Subject: 2013-2016 CX-5 AWD - KNOCKING NOISE FROM THE REAR OF THE VEHICLE	Bulletin No: 02-015/16
	Last Issued: 10/06/2016

2013-2016 CX-5 AWD vehicles with VINs lower than JM3KE*****852267 (Produced before Aug. 1, 2016)

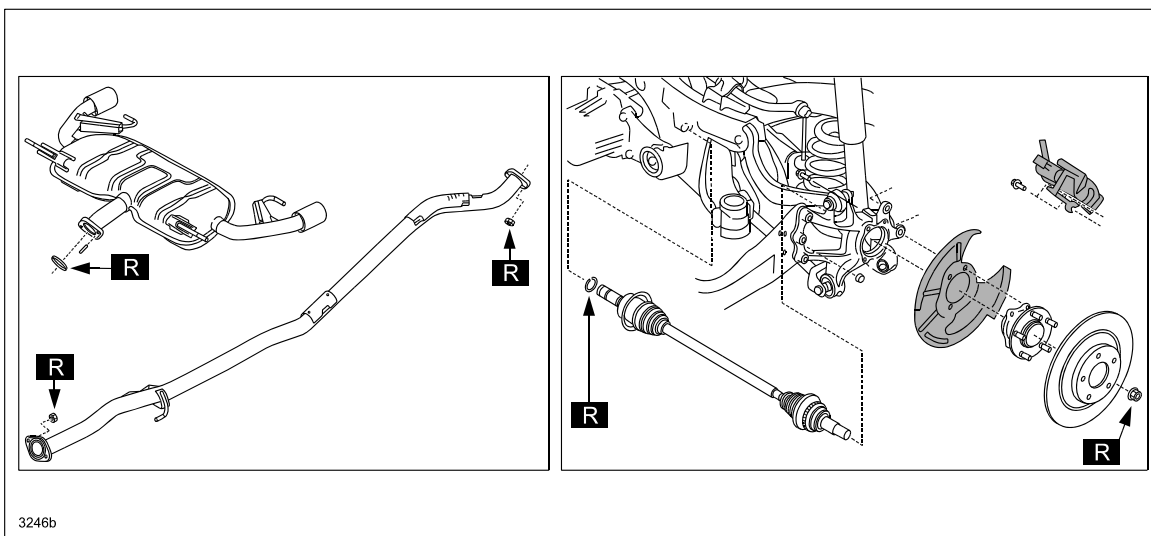
Some vehicles may exhibit a knocking noise from the rear of the vehicle. Upon inspection, cracks may be found in rear differential mount bushing, causing the noise. This is caused by insufficient durability of the bushing. To eliminate the noise, the shape of the bushing has been changed.

1. Verify the customer concern.
2. Replace the rear cross member with a modified one according to the instructions on MS3 online (REAR CROSSMEMBER REMOVAL/INSTALLATION [AWD]).
3. Verify the repair.
